DOCUMENT CHANGE REQUEST

DCR number	549	Changes required for:	General	Originator:	Steve Thacker - ESCC
Date:	2009/10/07	Date sent:	2009/10/07	Organisation:	
Status:	IMPLEMENTED

Title: Resistor Fixed Surface Mount Thin Film Non Hermetically Sealed,

Number: 4001/029 Issue: 1

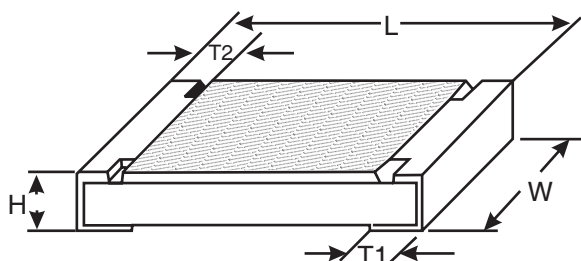
3. Figure 1 is deleted & the Parameter Derating Requirements moved to become note 1 to the Maximum Ratings table (in new Para 1.5).

- At $T_{amb} \leq +70^{\circ}\text{C}$. For $T_{amb} > +70^{\circ}\text{C}$ derate linearly to 0W at $T_{amb}=+125^{\circ}\text{C}$.
- Shall never exceed Limiting Element Voltage. R_n = rated resistance.
- Duration 10 seconds maximum.
